ADDENDUM No. 1
for
INDIANA STATE FAIR COMMISSION
DISCOVERY HALL TENANT
IMPROVEMENTS
1202 East 38th Street
Indianapolis, Indiana 46205

July 8, 2011

Cripe Architects + Engineers
3939 Priority Way South Drive
Suite 400
Indianapolis, IN 46240
Phone: (317) 844-6777
FAX: (317) 706-6464
www.cripe.biz

ADDENDUM NO. 1

PARTIAL SECOND FLOOR MECHANICAL PLAN

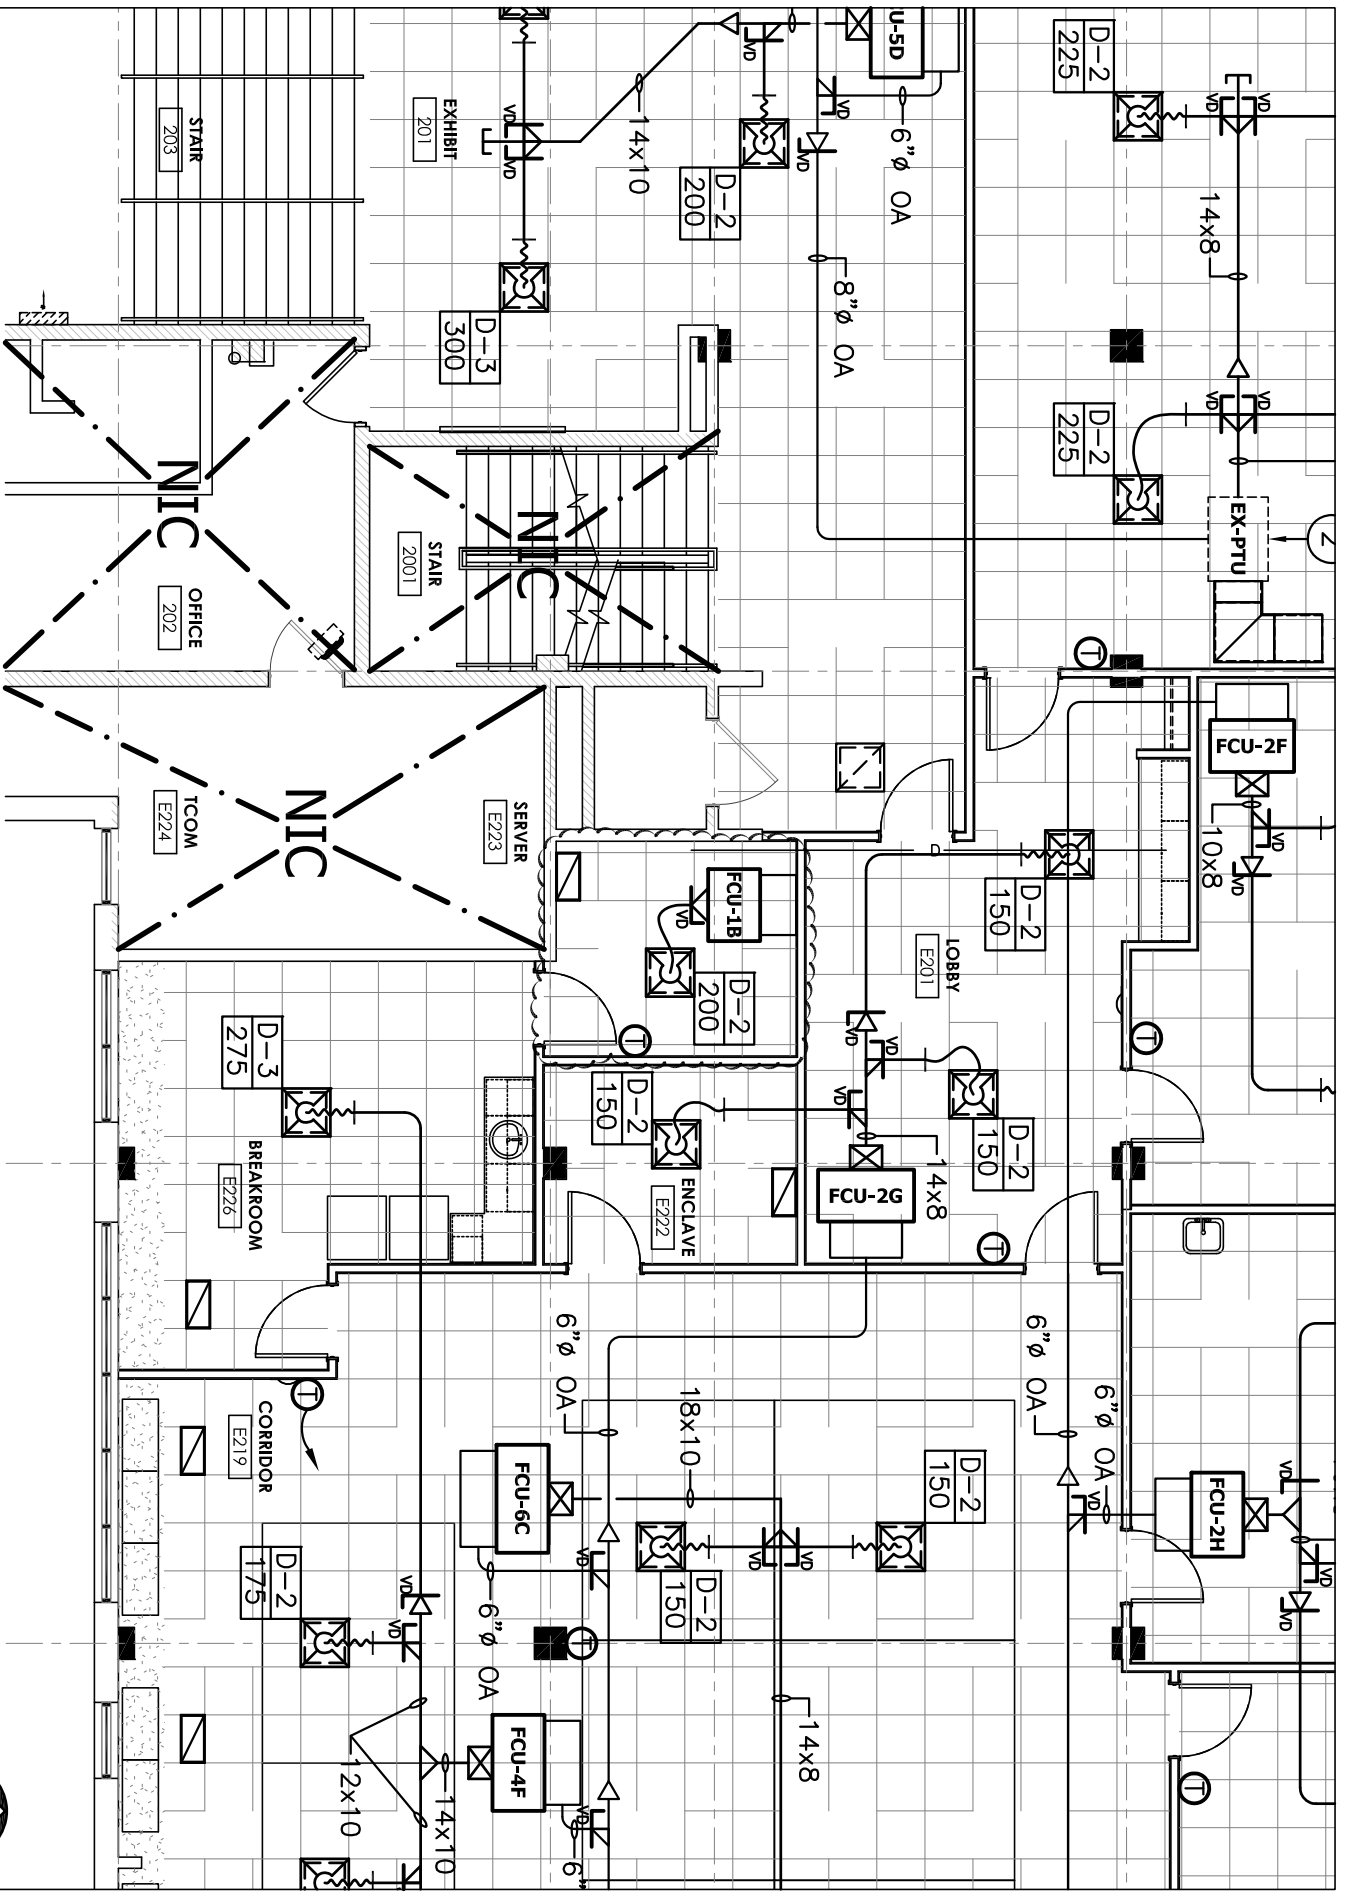
1. Add diffuser, thermostat, ductwork, volume damper, and fan coil unit FCU-1B to Server Room E223. See attached partial plan M102a.
2. From Plan Note 4, delete "x (length as shown)" and add to Plan Note 4 "All transfer air ducts will be made with fiberglass lined duct and shall include at least two 90 degree elbows."

PARTIAL FIRST FLOOR MECHANICAL PIPING PLAN

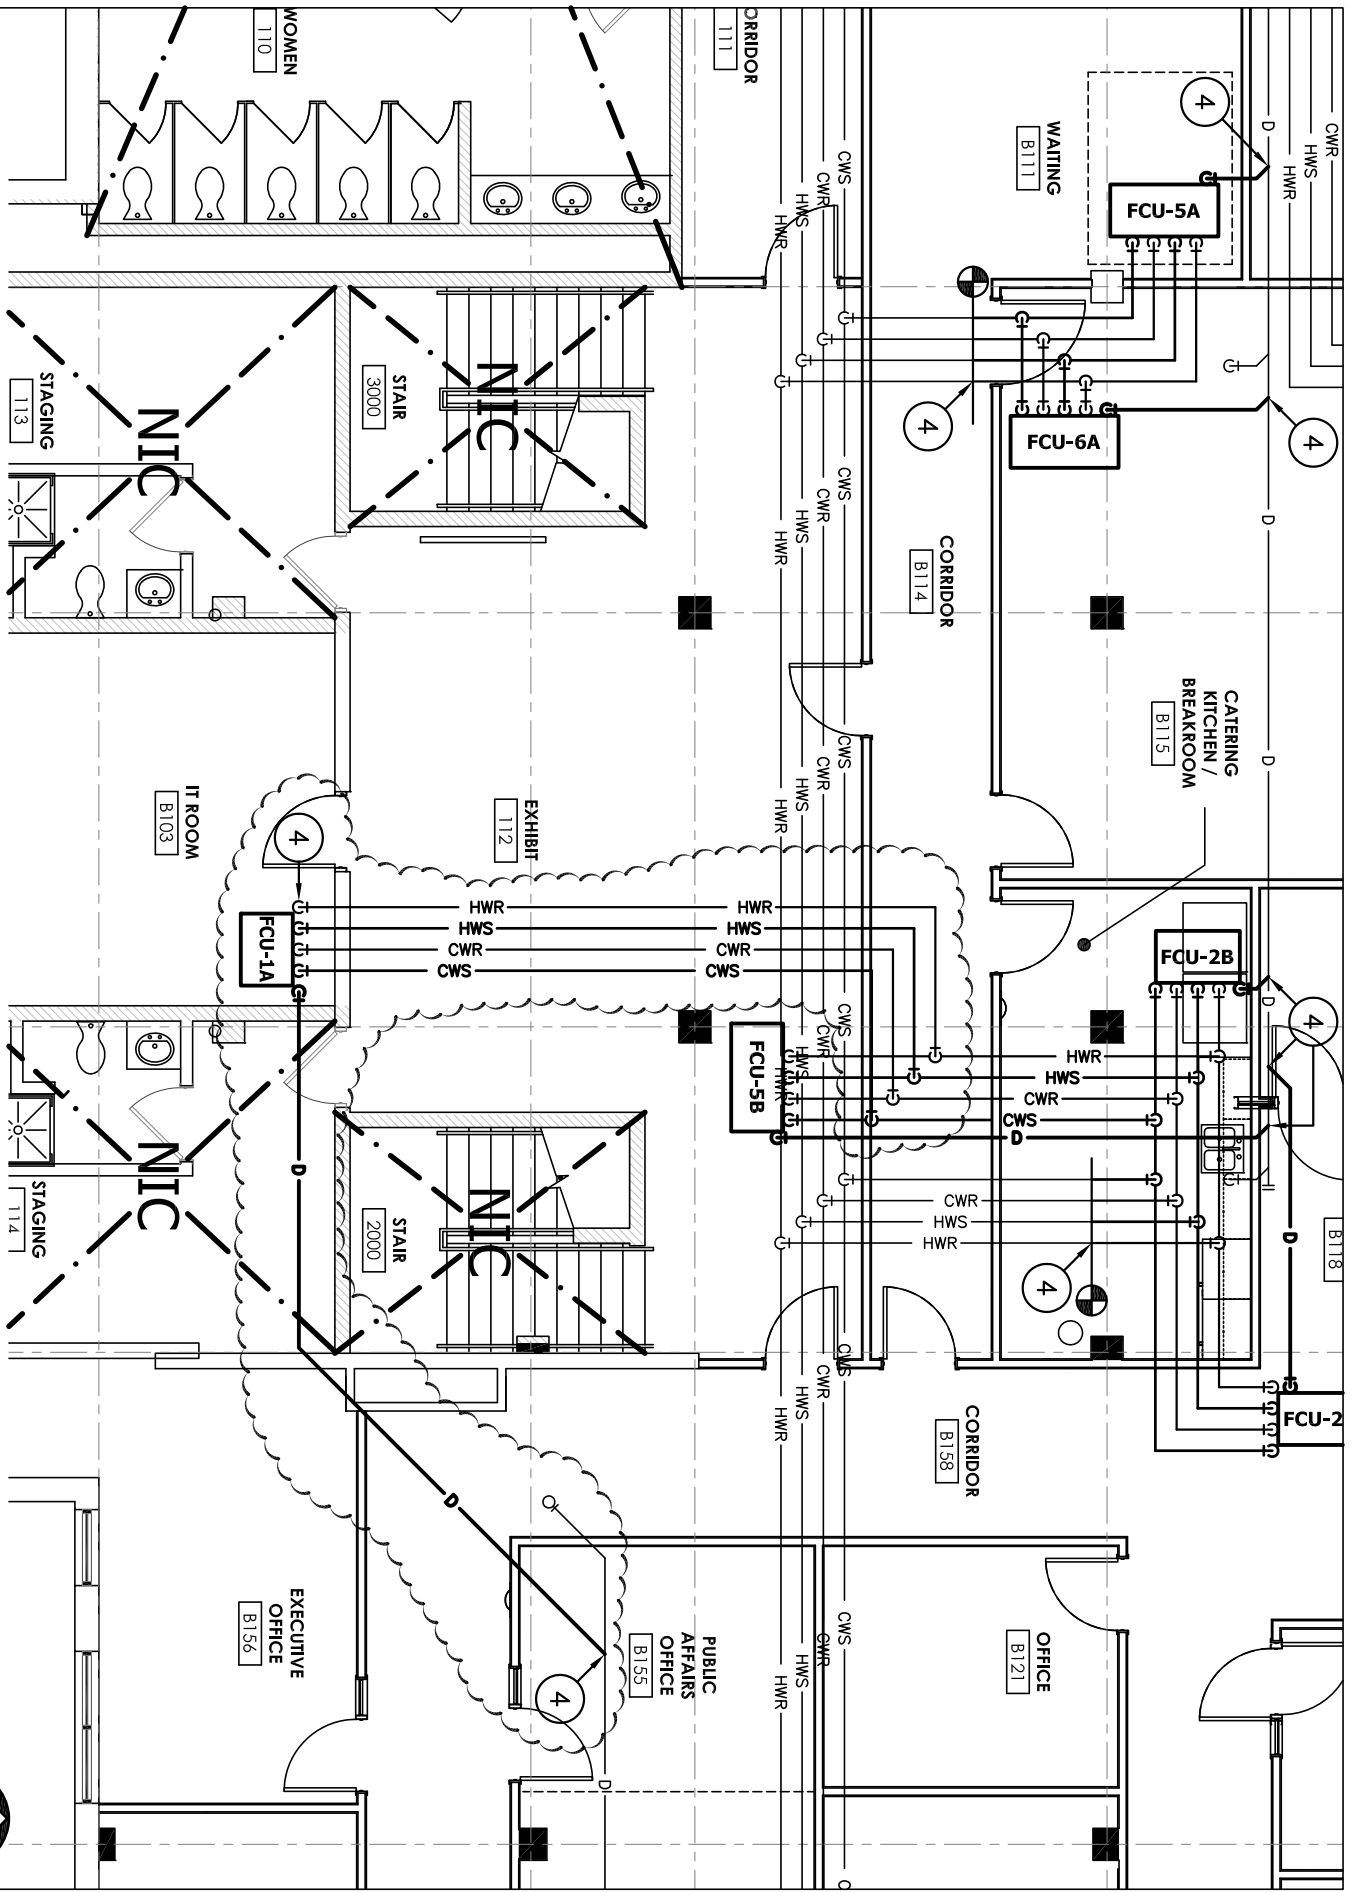
1. Provide hot and chilled water piping to the new fan coil unit FCU-1A. See attached partial plan M103a.

PARTIAL SECOND FLOOR MECHANICAL PIPING PLAN

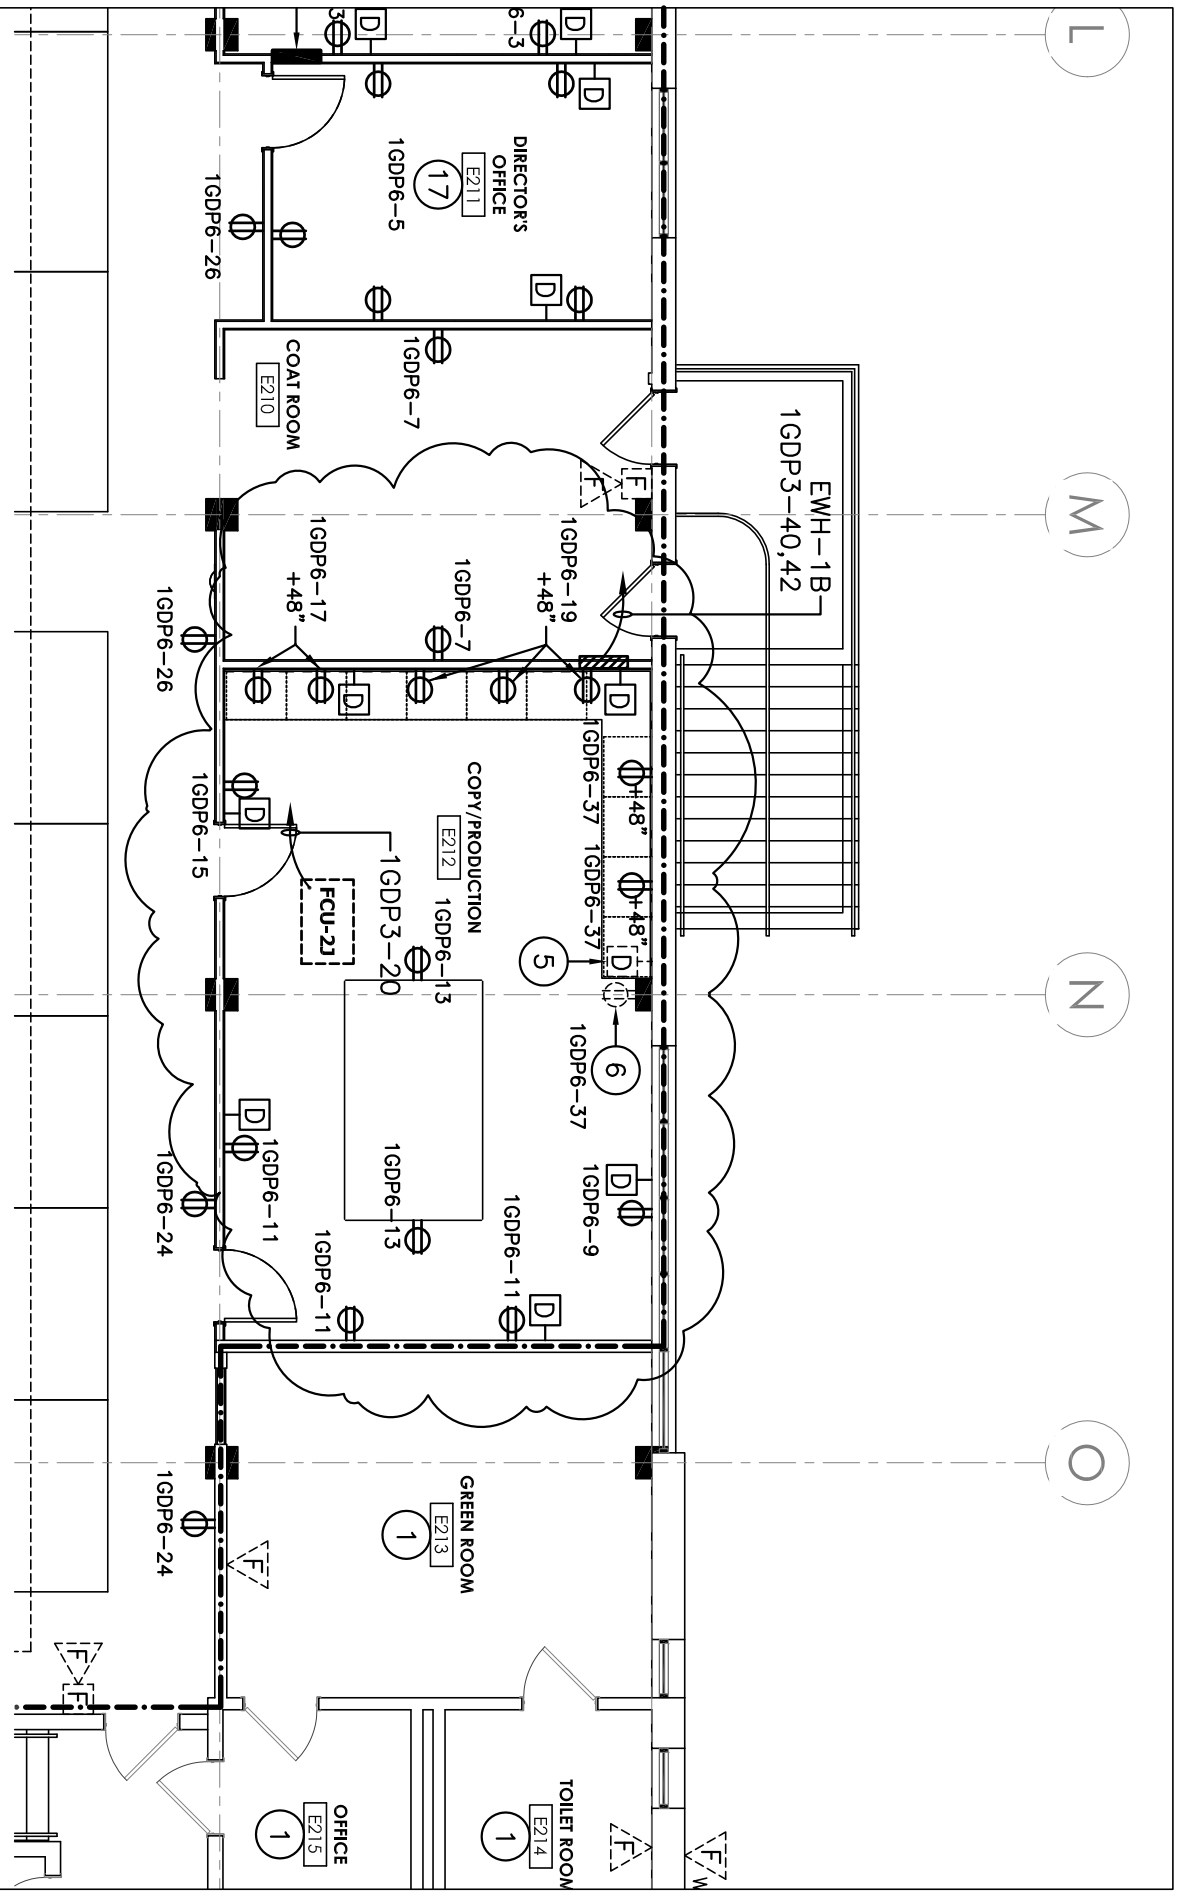
1. Provide hot and chilled water piping to the new fan coil unit FCU-1B. See attached partial plan M104a.
